CITY OF CONWAY, ARKANSAS HISTORIC DISTRICT COMMISSION

October 26, 2020 · 5:30pm · City Hall · 1111 Main Street

A. 517 Fifth Street - New Single-Family Residence

A. 857 Mitchell Street - Exterior Modification & Garage Addition

ELEVATIONS

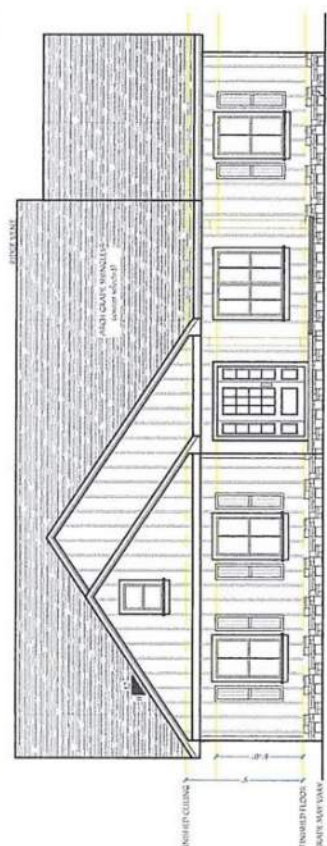
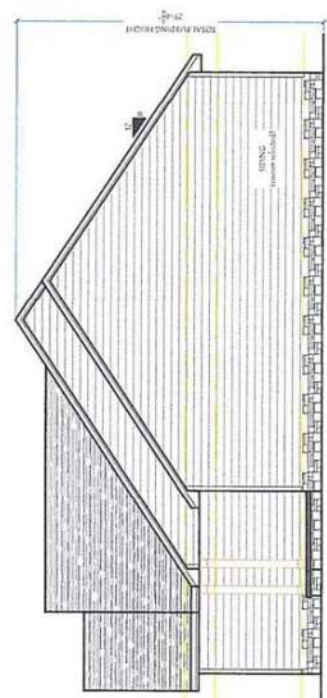
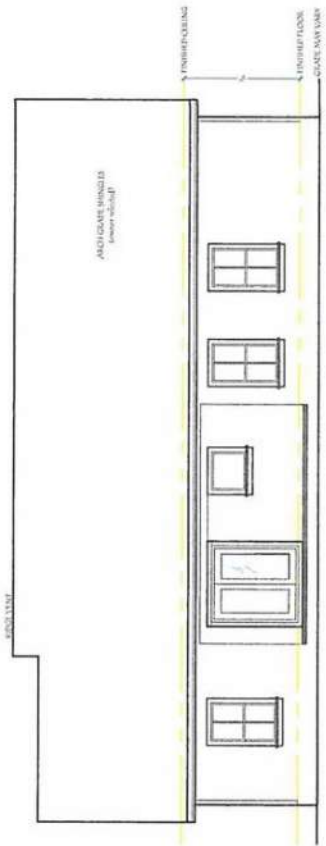
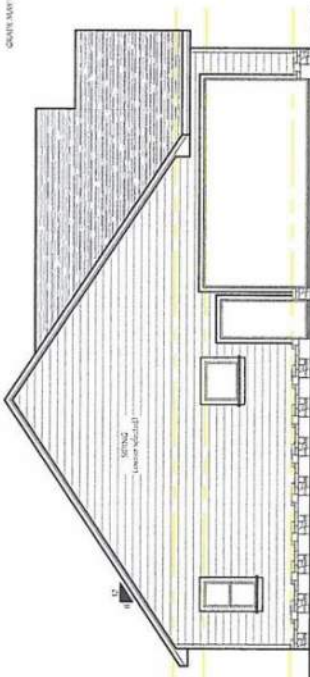
The height of the structure at 22' and the width at 50' will not be out of scale of the pattern of the neighborhood. The structure will be one story. There are predominantly one-story structures in the immediate vicinity.

Façade, wall area, rhythm. New facades shall be compatible with those of the surrounding area. 25-40% of front façades should contain windows. Window and door openings should relate to the size and proportions contained in the surrounding area.
The front façade will be composed 32% windows and openings, which based on the design appears to be appropriate. The side facades are largely bereft of any windows, which is not compatible with the intent of the regulations. Consider requiring additional side windows.

Architectural Details, Siding, and Bricks. Detailing and siding should complement the surrounding area. Siding should include brick, stone, wood, or Hardieboard/LP Smartside type siding.
The applicant is proposing to use vinyl siding for the home. This is not compatible with the regulations. Recommend requiring Hardieboard or similar wood equivalent product.

Shutters, Roof, Decks/Plaza Space, Skylights, Mechanical Screening. Roofing should respect the character of the surrounding area with respect to materials, pitch, and form. Metal roofing is prohibited unless historically used on the structure.
Roof forms and materials are appropriate. The applicant is proposing 10:12 roof pitching, which is appropriate.

1. Permit up to a 12' concrete driveway.
2. Require the planting of one canopy tree in the front yard (two if the existing crepe myrtle is removed).
3. Require windows to be true divided lights or 1 over 1 if not true divided light.
4. Require cladding in Hardieboard or similar wood equivalent product.
5. Require front walkway to connect to the street.
6. Require 5' sidewalk with a 5' setback from the back of curb.
7. Require fascia and soffits to be finished with wood construction.
8. HVAC equipment be placed in a manner to minimize its visibility from the street.

1. Consider requiring additional windows along the side facades.

857 MITCHELL

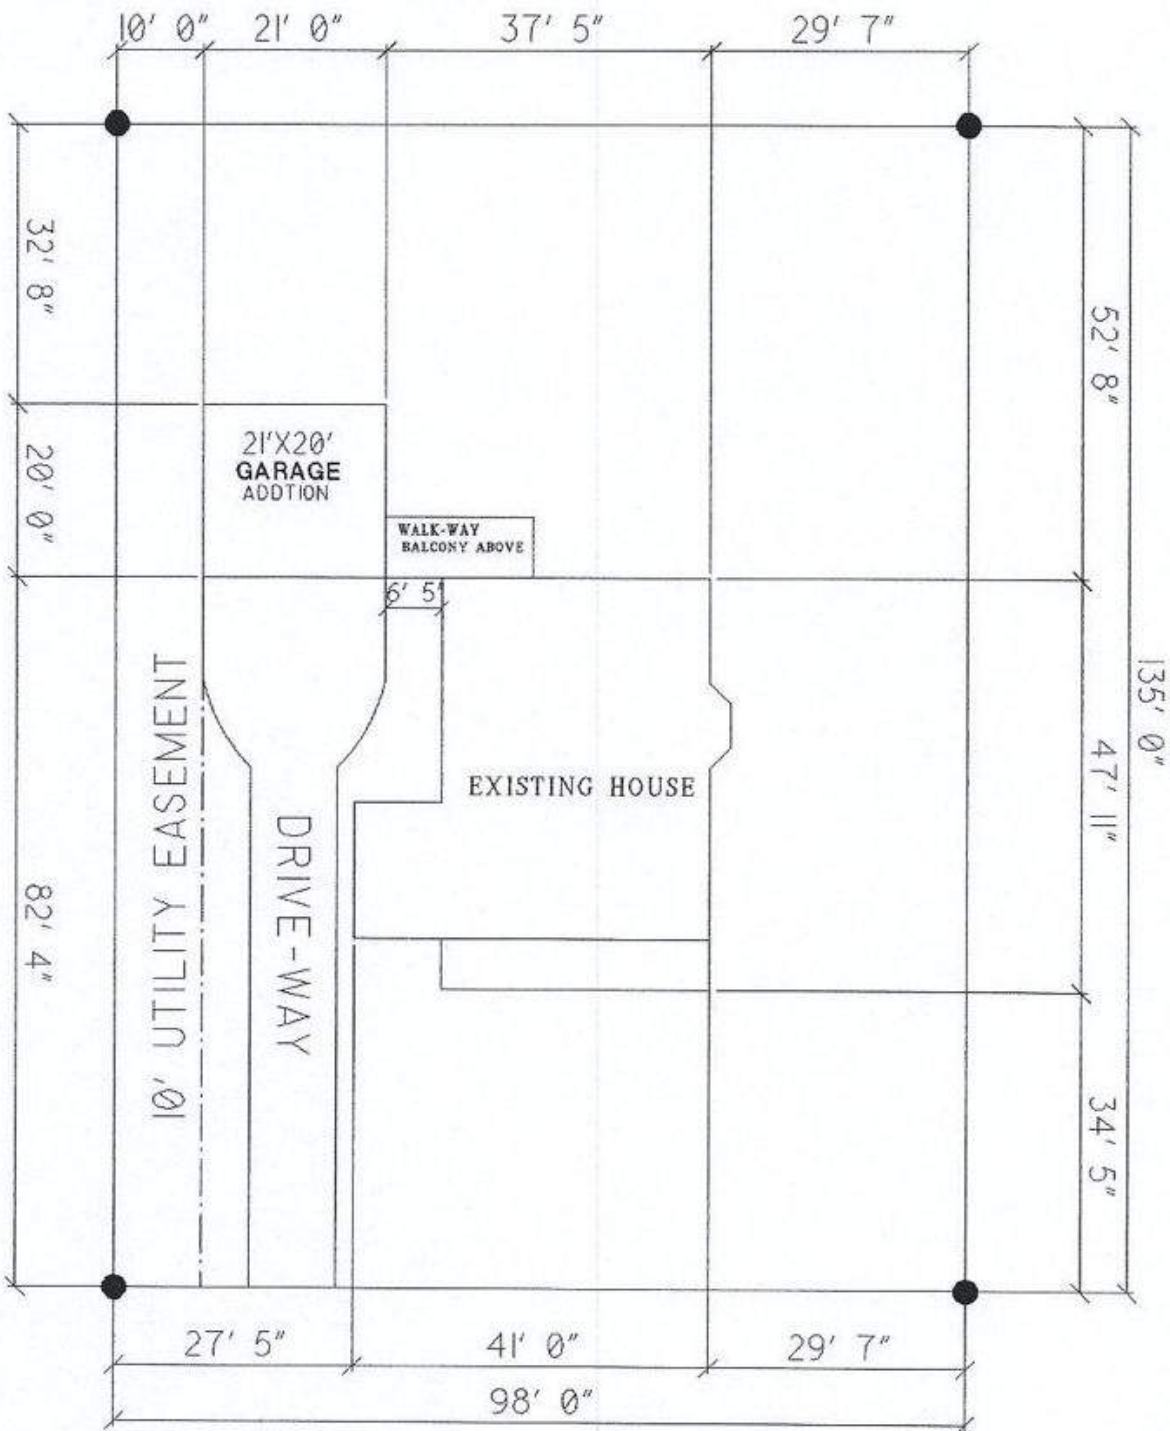
The garage is proposed at the immediate rear of the structure with a hipped roof form, connected by a walkway/balcony. Placement further back on the lot is recommended. Historically, the site had a side loading garage with a gable roof form that matched the primary structure. While sidelading of the garage is not advantageous on this site, a gable roof form is recommended. The applicant is proposing a new 10' driveway. This width is appropriate.

6. The garage shall be placed further back on the lot, clad with wood or Hardieboard matching the original wood siding on the house, and changed to a gable roof form to match the house.

7. The driveway shall be restricted to 10' in width and allowed to taper to 21' in width behind the mid point of the house.
8. One additional canopy tree shall be required in the front yard.

WEST ELEVATION

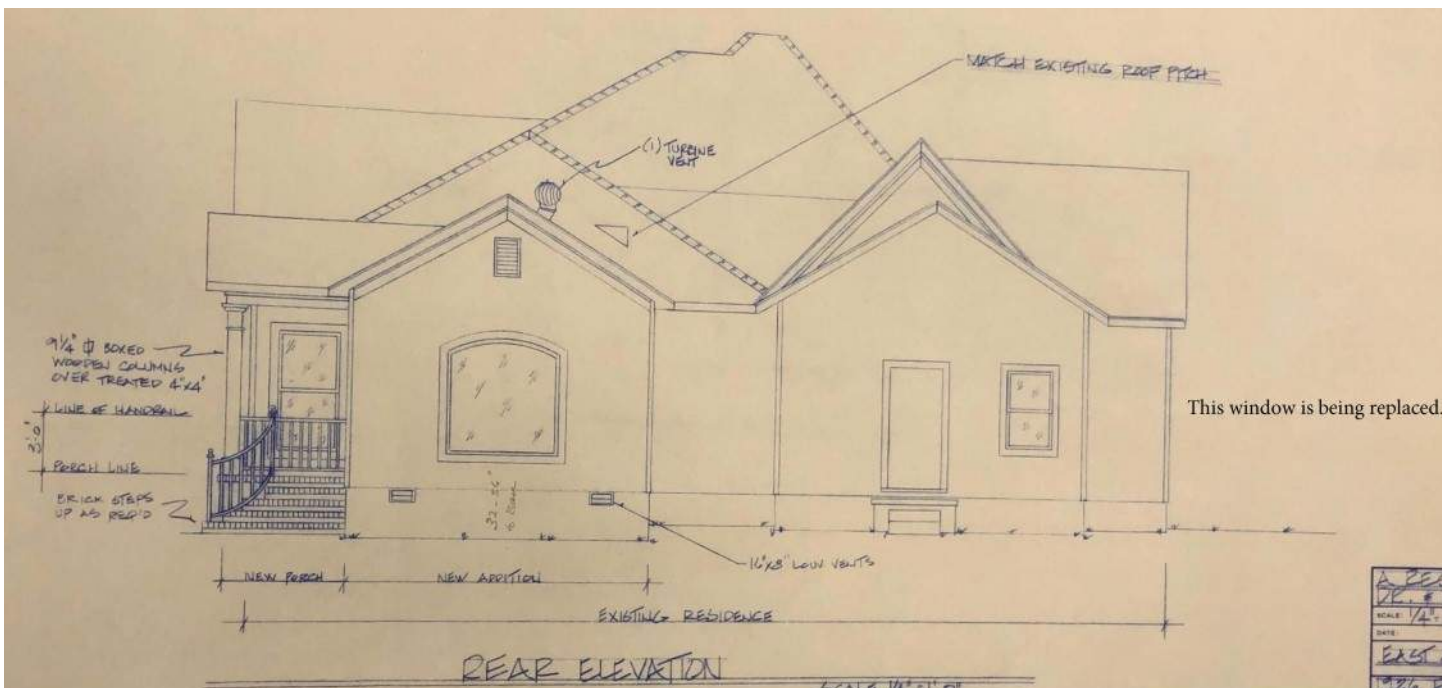
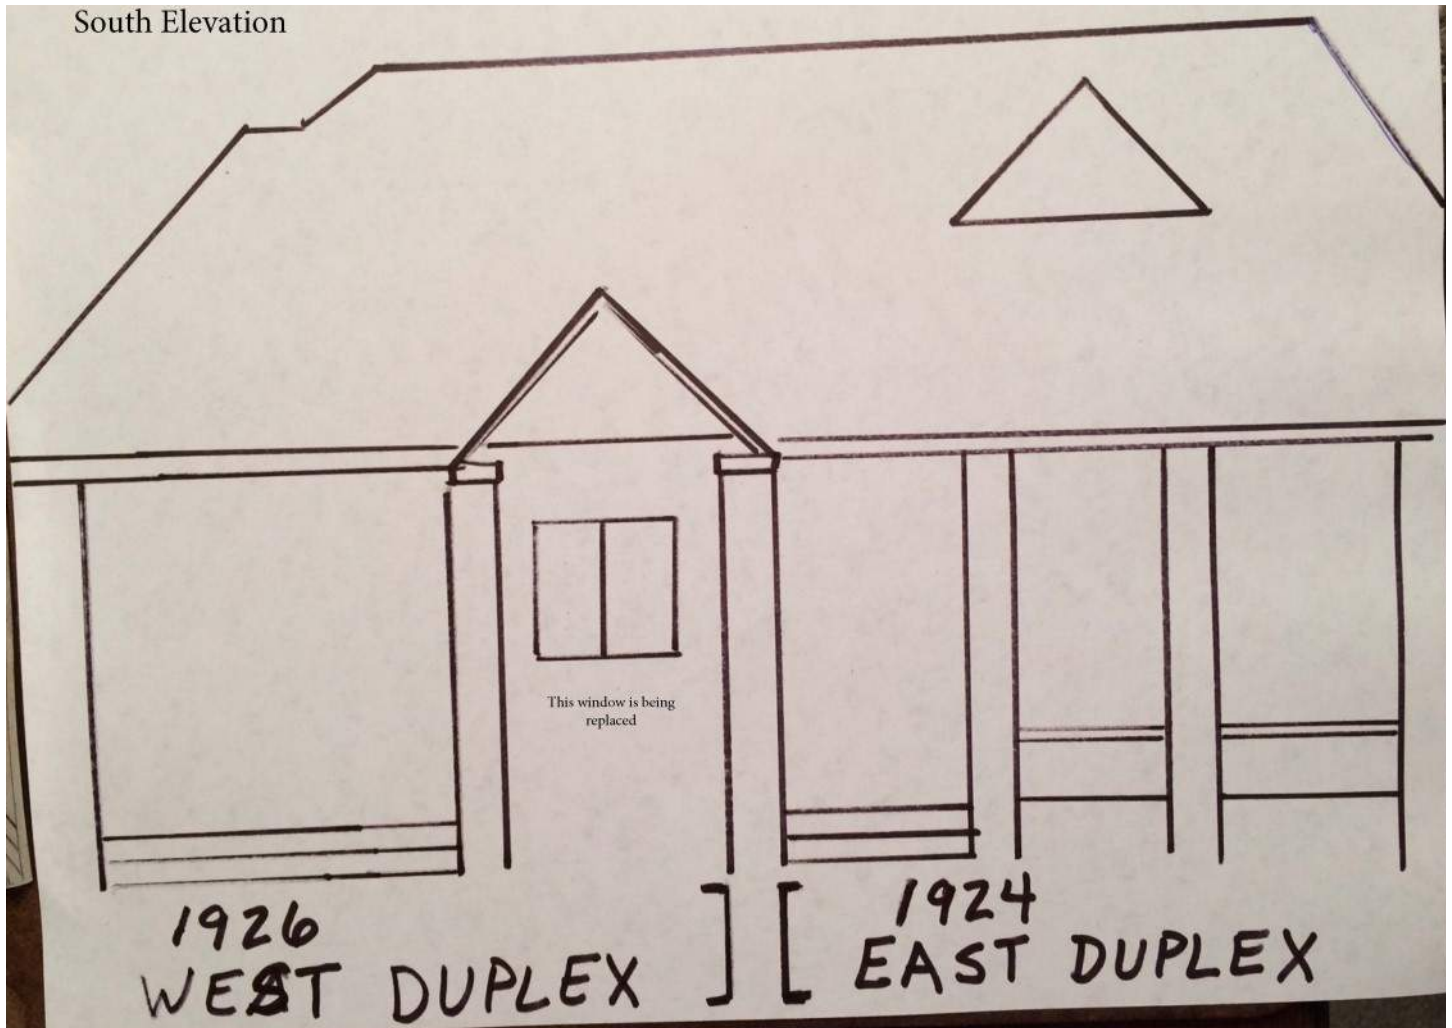
The applicant is proposing to remove the existing vinyl siding on the west side of the structure. The applicant is proposing to replace the existing wood siding with Hardieboard siding to match the original form of the wood siding. The guidelines discourage wholesale removal of original wood materials. Consider requiring that Hardieboard replacement only be used in areas where the existing wood siding is too damaged or rotten to be repaired.

Windows on the east side of the duplex have been replaced resulting in a non-uniform appearance on the structure. The proposed window replacements will maintain the original dimensions of the existing windows including styles and will be wooden. Given these conditions, replacement is appropriate.

all windows being replaced

3. Replacement of the wood siding beneath the existing be limited to only those portions which are too damaged or rotten to be retained.

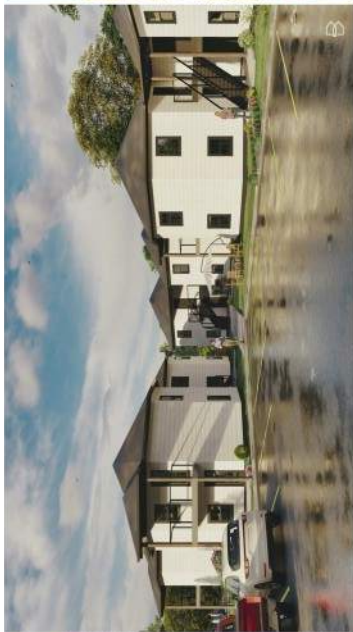
Recommend requiring a specific landscaping plan to indicate plantings to screen the parking areas from view of the right-of-way and adjacent properties. (Indicated by black clouds) Recommend requiring removal of asphalt and planting put in place of paving. (Indicated by blue clouds).

1. Require a specific landscaping plan, providing plantings to screen the parking areas from view of the right-of-way and adjacent properties, to remove portions of the existing asphalt parking that will not be necessary with the new striping plan, and to provide for interior and frontage plantings in conformance with these regulations.
2. Require a lighting plan.
3. HVAC equipment be placed in a manner to minimize its visibility from the street.
4. Plans shall be resubmitted to the Planning Director for approval prior to issuance of the COA.
